MANDATORY SERVICE BULLETIN**CATEGORY 1****The Subject Matter Of This Service Bulletin Is Incorporated
In Whole Or In Part In An FAA Airworthiness Directive****MSB644****SUPERSERDES SERVICE BULLETIN 637
FAA APPROVED****SUBJECT:****REPLACEMENT OF MAGNETO COILS AND ROTATING MAGNETS****REASON FOR
BULLETIN:**

To reduce the compliance time originally specified in Bendix Corporation Service Bulletin 560A, therefore, retiring from service certain older coils and rotating magnets. This bulletin also requires the replacement of various coils that were previously acceptable under the instructions listed in its original 1972 issuance.

Figure 1. Rotating Magnet Types to be replaced

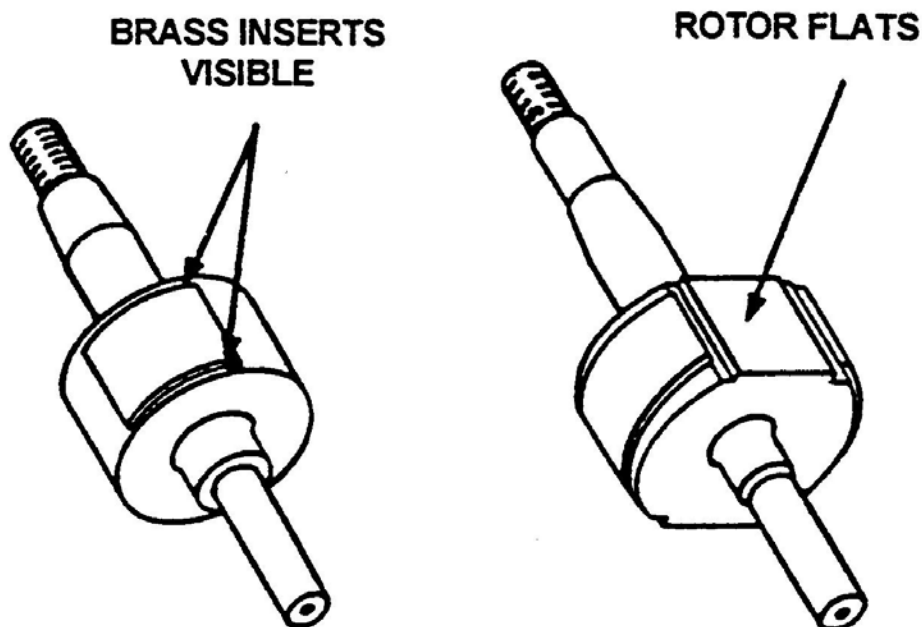
- A. COILS: (S-20, S-200, S-1200 Series Magnetos only) Disassemble magneto as specified in the current applicable service manual to allow access to the coil. All Bendix coils which cannot be identified as detailed under the heading "Replacement Coils" in Table 1 must be replaced.
- B. ROTATING MAGNETS: (S-20, S-200, S-600 Series Magnetos only) Disassemble magneto as specified in the current applicable service manual to allow full visual inspection of the largest diameter of the rotating magnet surface. Rotating magnets which display the characteristics shown in Figure 1 (i.e. flat magnet sides or brass lamination inserts) must be replaced.

While current rotating magnets differ in shaft length, thread pitch, and keyway location, they all incorporate round rotating magnet casting and laminations of a dull iron color. Refer to the current applicable service manual parts list to determine part number of replacement rotating magnet.
